Evans services coordinated into the apartment plan

Unpublished G2-P2 proposal. User review required before adoption; published v67 and Google Flow v66 stay unchanged.

Replace the 18 earlier nominal wet-room boxes with eight continuous wet-stack groups and two dry risers. Keep separate wet and electrical rooms, fit two 3-bedroom homes with studies, and provide refuse/recycling storage at the rear alley.

EV-G2-P2 · UNPUBLISHED · Engineering and accessibility approval remain open

A credible service layout gives back some area

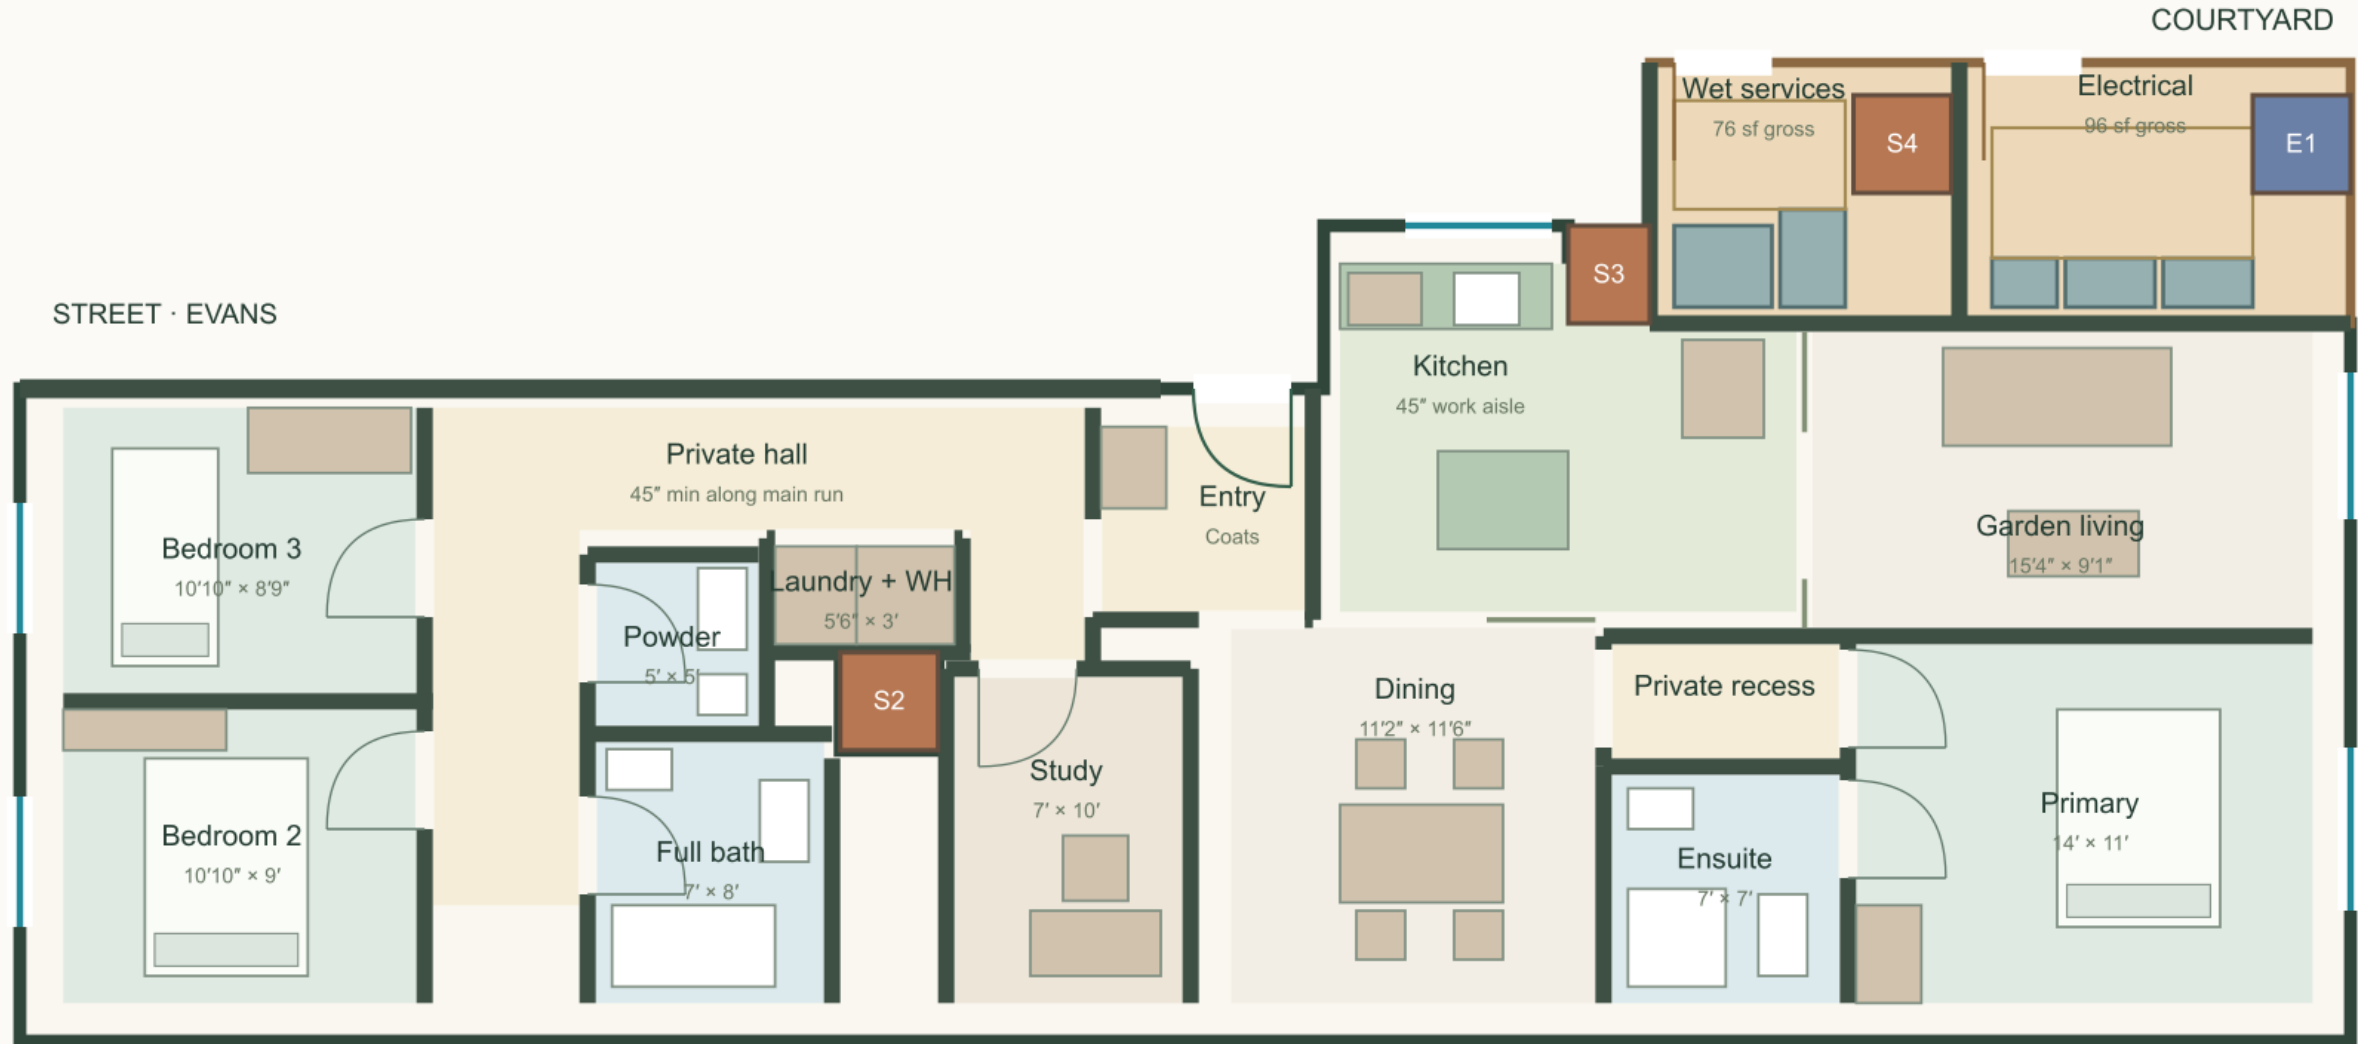
Original EV-G1 → G2-P2. Gross apartment figures exclude dedicated shaft reservations; measured net remains unverified.

Apartment gross
19,090 → 19,514 sf

Efficiency
86.9% → 88.9%

Versus G2-P1
-536 sf

Two revised 3BD
homes; full project
family count unverified

Two mirrored 3-bedroom homes, with a separate study

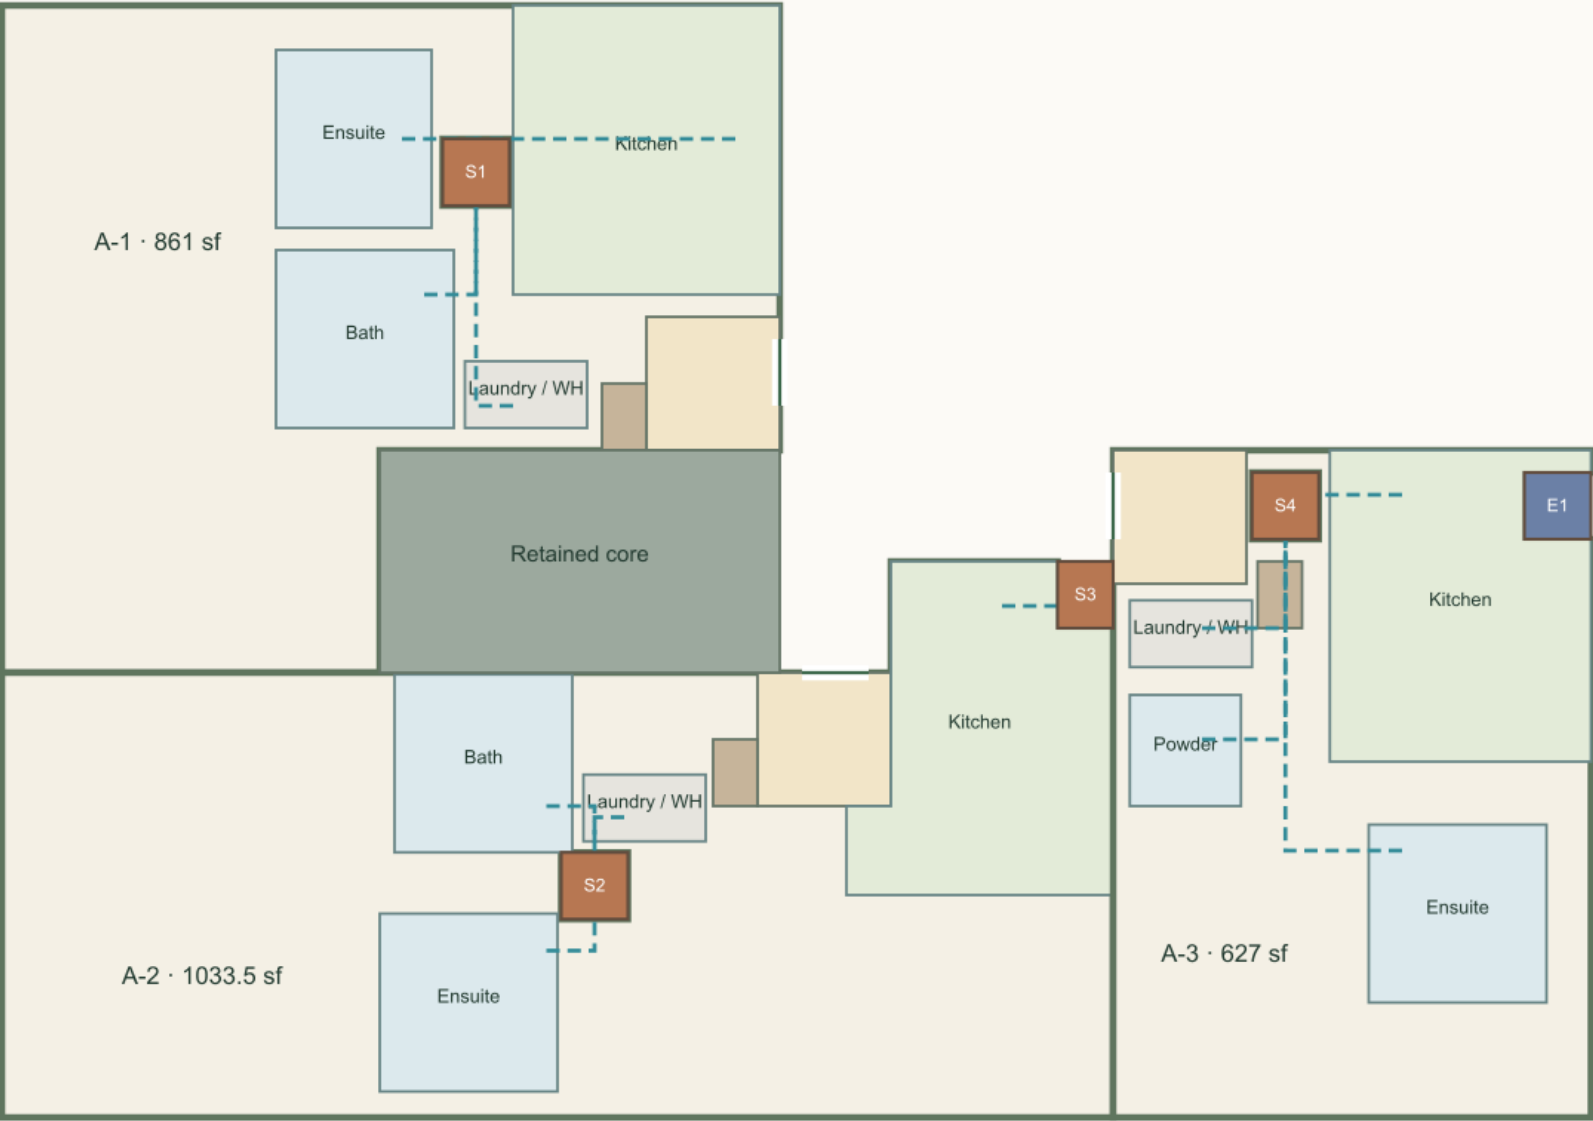
Building A shown; Building B is an exact north–south mirror. 1,506.5 sf apartment gross per home.

Clear room zones: primary 154 sf · bedroom 2 97.5 sf · bedroom 3 94.8 sf · study 70 sf.

Both bedrooms at the street and the primary face real modeled windows. The living room now has direct garden light.

Kitchen sits on the recessed courtyard wall, with a 4 × 3-ft island, light screens, and a direct dining connection.

Three-foot nominal room doors enter partitioned halls/recesses. Final clear openings and maneuvering spaces remain unapproved.

Three bedroom clear zones and direct windows fit; legal bedrooms and accessible room details unapproved.

Verify glazing, operable area, escape/rescue applicability, sash clear openings, sill heights, fire separation and structure; complete ICC A117.1 door maneuvering, bathroom and kitchen clearances. Study remains non-bedroom. Upper homes and the two existing ground 1BD homes have service-module layouts, not complete room fits.

Upper wet rooms connect to continuous shafts

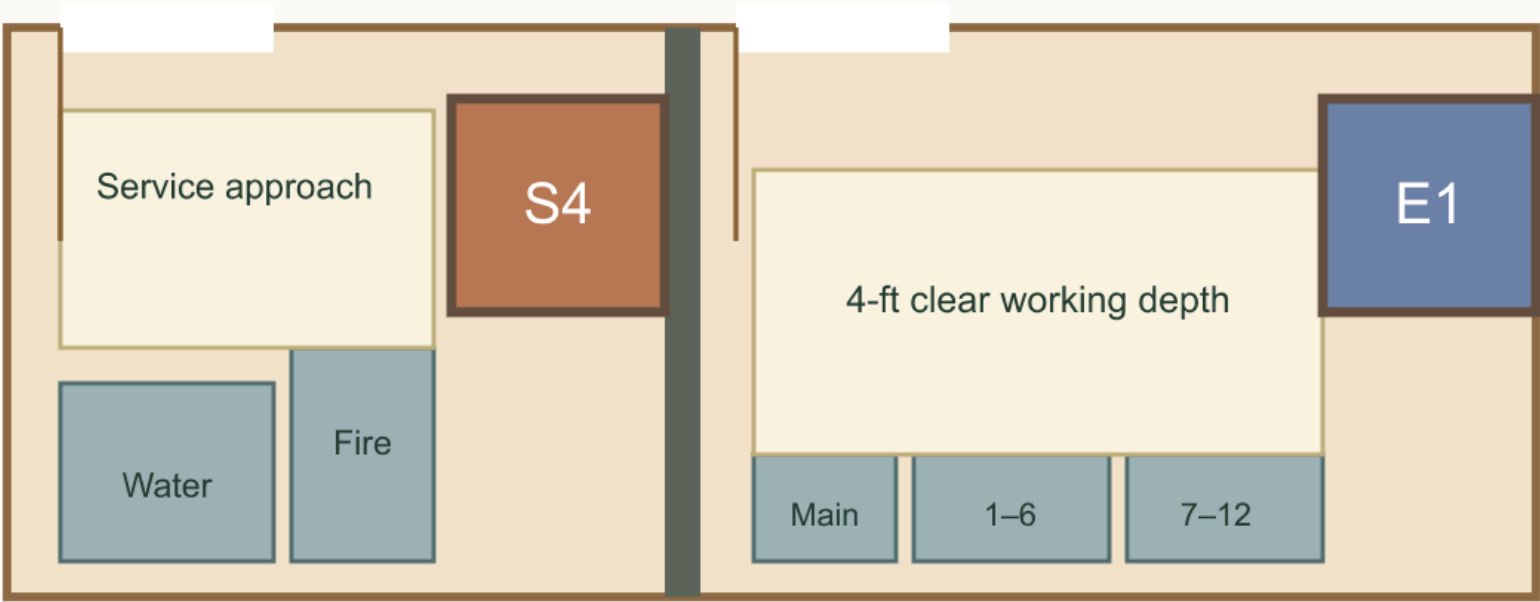
Revised wet modules preserve the unit boundaries and entry vestibules. Remaining upper room plans are not fully fitted.

B uses the exact mirrored layout.

18 former boxes → 8 wet stacks
plus 2 separate dry risers.

Separate wet and dry services, with real working space

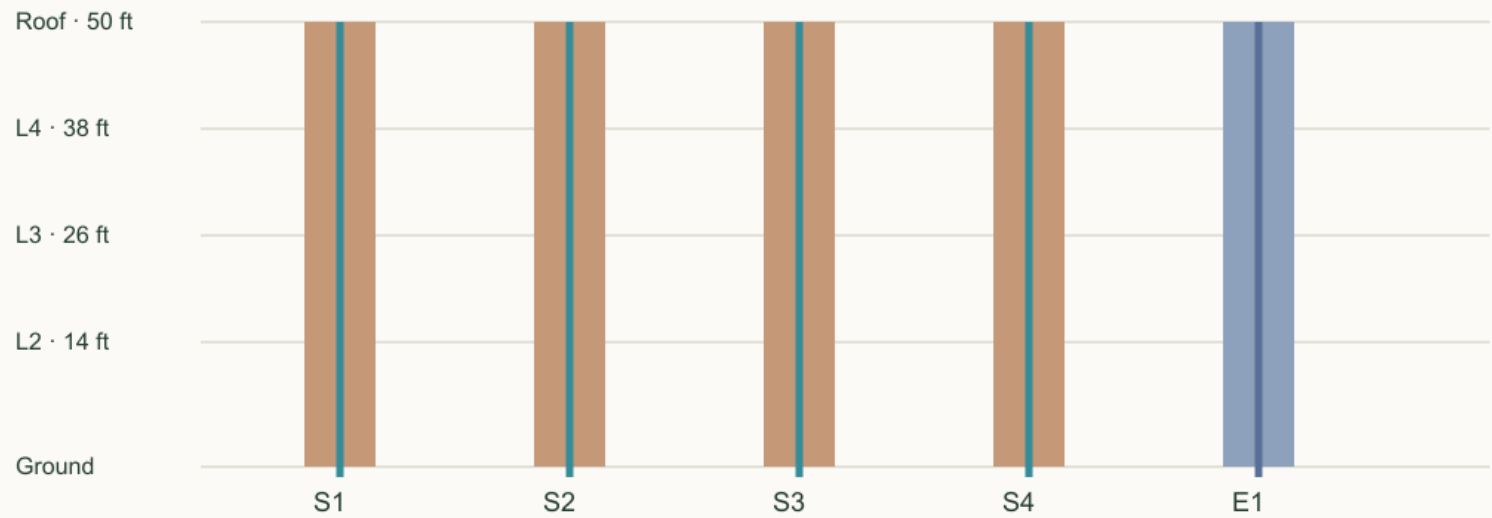
Equipment blocks are planning envelopes. Supplier selection and loads must fit these spaces or trigger a documented refit.

172 SF GROSS / BUILDING

- Wet room: 76 sf
- Dry room: 96 sf
- 12 electrical meter positions
- 11 homes + common service
- No wet branches above the electrical equipment footprint.
- One-hour electrical enclosure minimum; rated assembly pending.

- Vertical shaft geometry is continuous.
- 24-in horizontal service band reserved below upper floors; beams unresolved.
- Vents reach the roof coordination level.
- Termination height / penetrations need MEP and roof detailing.

Equipment envelopes have been fitted, but capacity is not engineered.

Provide 11-home plus common-service electrical load per building, voltage, ComEd meter/switchgear dimensions and clearances; water pressure/flow, backflow and sprinkler calculations; confirm whether fire pump/tank or transformer is needed. Selected equipment must fit 76-sf wet + 96-sf dry rooms or trigger a documented refit.

An on-site service enclosure at the rear alley

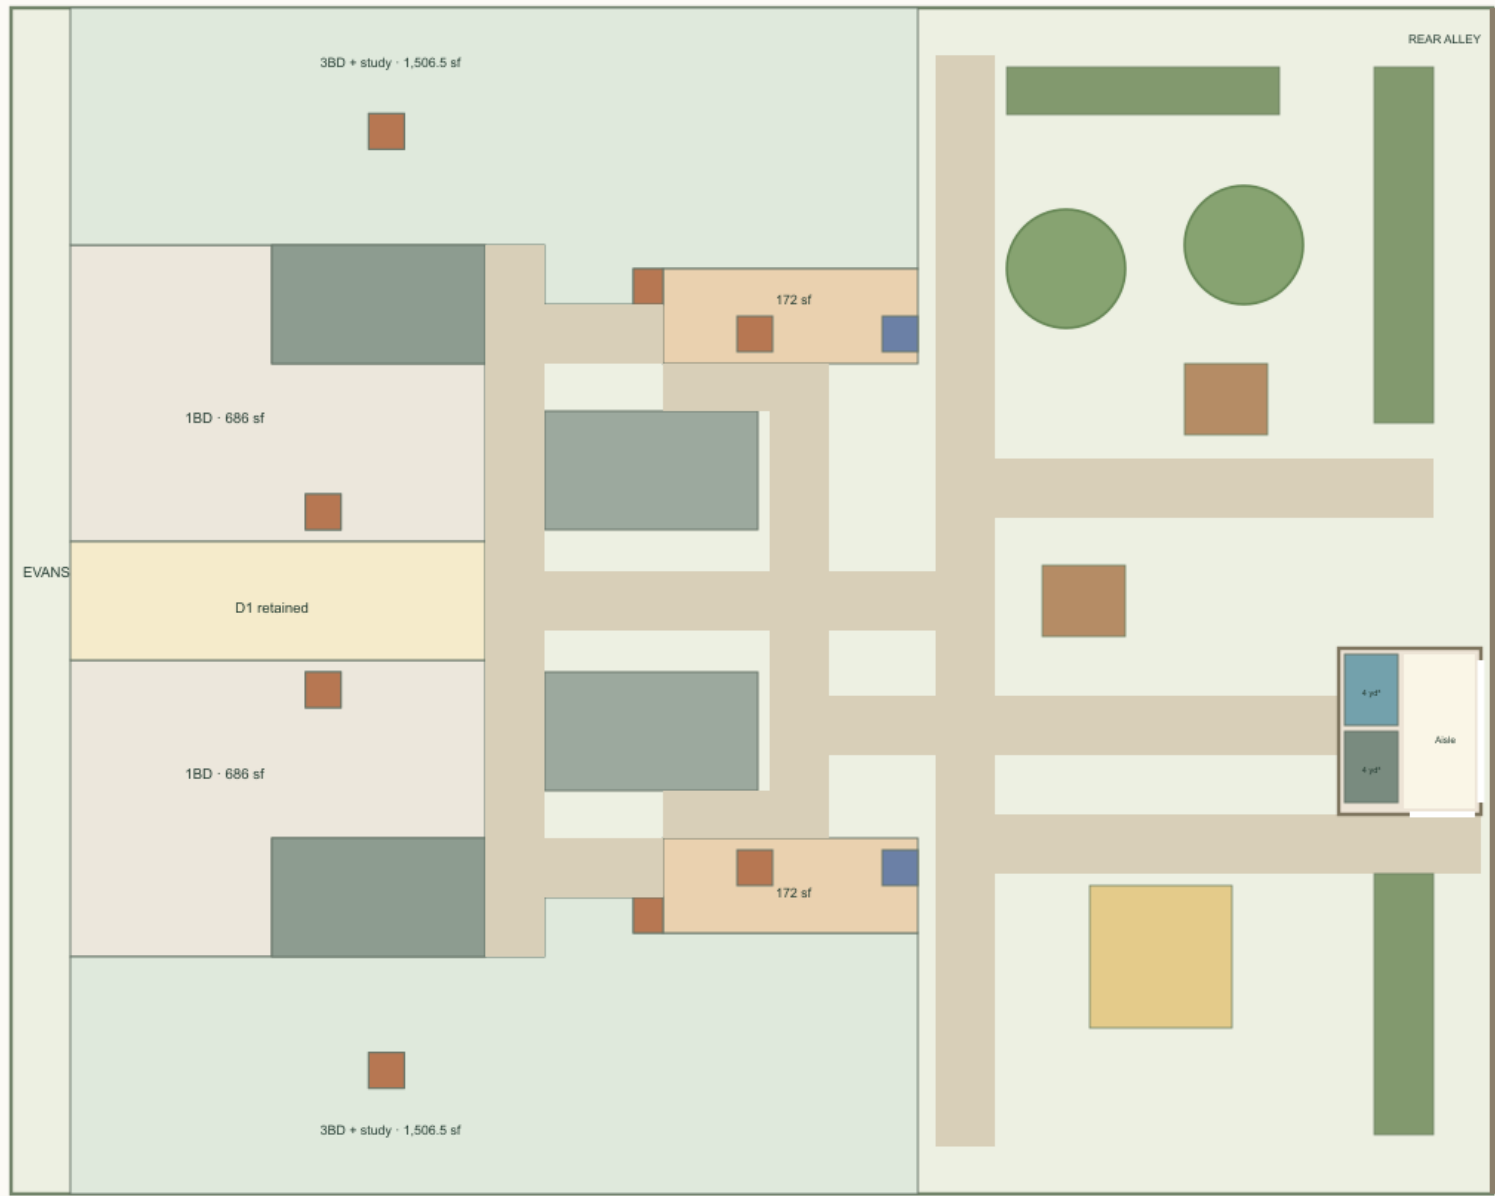
A clear resident route and collection aisle are drawn separately. RFP/GIS supports an alley; dimensions and levels need a survey.

REFUSE + RECYCLING

12 × 14-ft enclosure · 168 sf
Two nominal 4-yd³ containers
8 yd³ storage / 5.5 yd³ weekly
minimum allowance for 22 homes

5-ft resident path connects to
the existing garden route.

6-ft clear roll-out aisle;
12-ft gate faces the alley.

East picnic table relocated.
Planting shortened at new path.

Verify survey, grades, truck access,
collection method, container sizes
and waste generation.

Rear alley is supported by the RFP/GIS map; actual dimensions and grades are not surveyed.

Confirm parcel boundary/alley width, service-lane clearance, collection vehicle/door operation, bin manufacturer sizes, frequency and waste split; confirm actual waste generation against the 50-cubic-yard weekly compactor threshold, drainage and nuisance control. Survey thresholds and slopes for the continuous ground paths. Resolve the RFP 125×100-ft rectangle versus earlier GIS area.

Continuous stacks and drawn ground connections

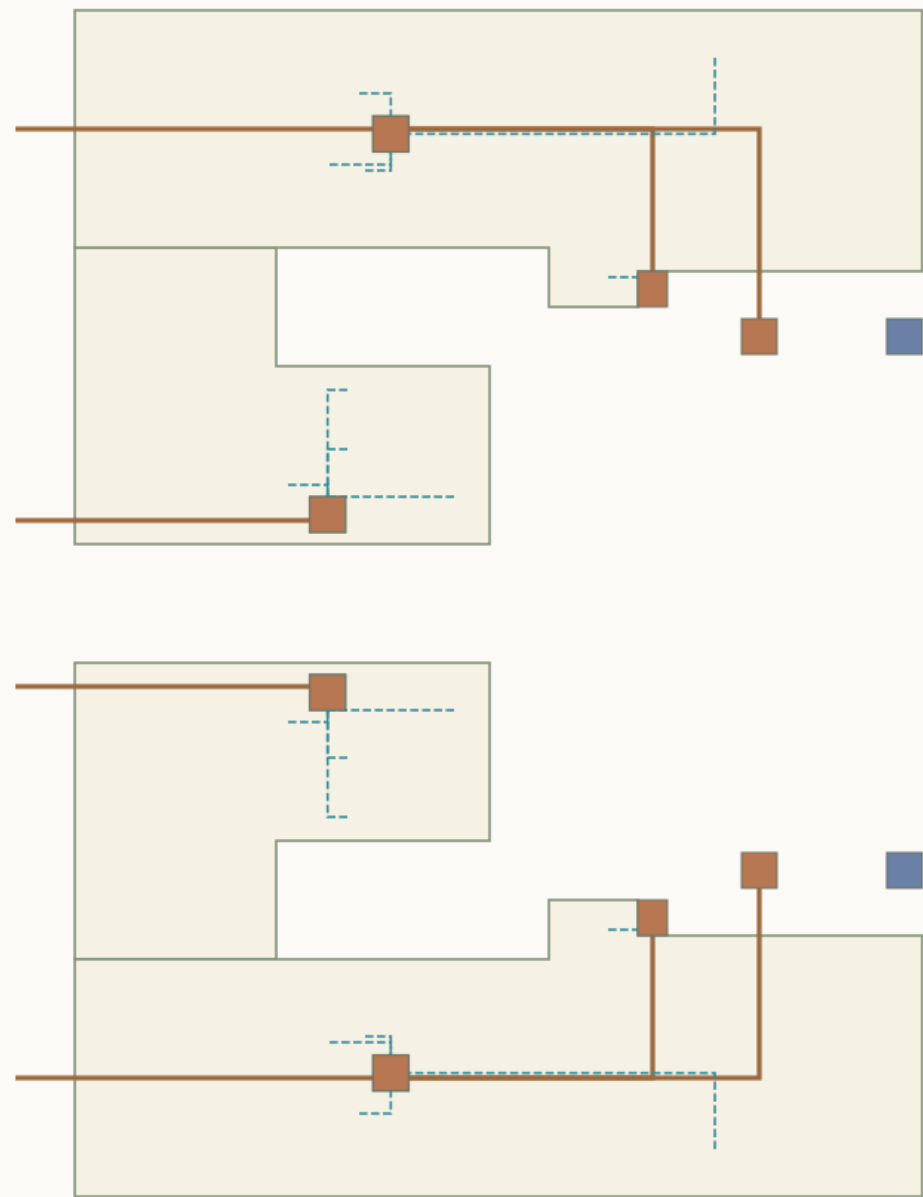
B mirrors A. Branches are under floor / underslab reservations and do not occupy the clear room zones.

18 old wet-room corner boxes map to S1–S4.
12 of those boxes conflicted with G2-P1 rooms.
No verified installed risers were found.

Blue dashed: ground fixture branch reservation.
Ochre: underslab collection toward Evans.
Supply, sewer tie-in points and inverts are unverified.

Longest ground branch: 33.8 ft

Planning fall at ¼ in/ft: 8.4 in
MEP must confirm pipe sizes, venting and invert.

Every branch ends inside its assigned stack.
Upper branches repeat on all three upper floors.
Dry electrical risers remain separate.

Continuous shaft topology and branch paths drawn; sizing, fall and supports unapproved.

Size DWV/vent/water/fire systems; establish sewer location/invert, cleanouts, trap-arm vents, penetration/firestop details and slab/beam coordination. Longest ground branch has a 1/4-in/ft planning fall budget recorded separately. Verify distinct waste/vent/air paths inside gross shafts, and roof termination clearances. Roof/cornice remains 50 ft; no above-roof outlet has been assumed complete.

Actual wall openings and retained D1 portals

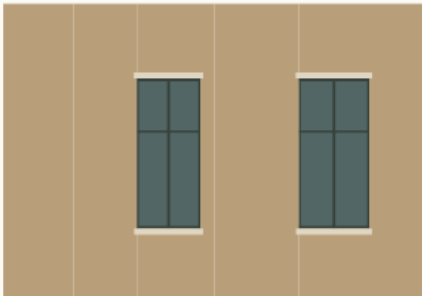
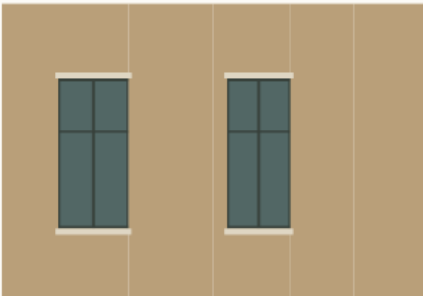
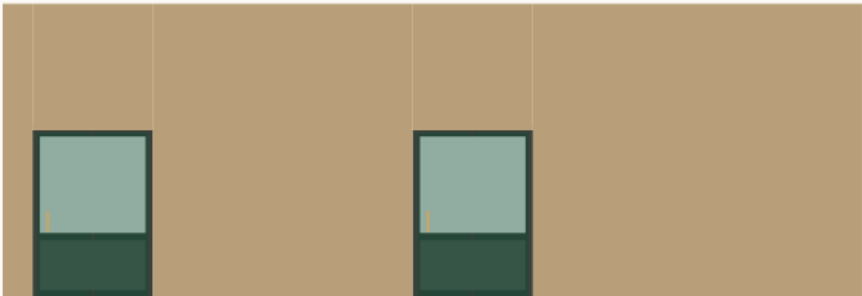
Identical orthographic cameras for street before/after. Utility openings are modeled holes, with frames and doors.

Eight new bedroom/living windows; four utility doors; eight courtyard windows shortened to clear S3.
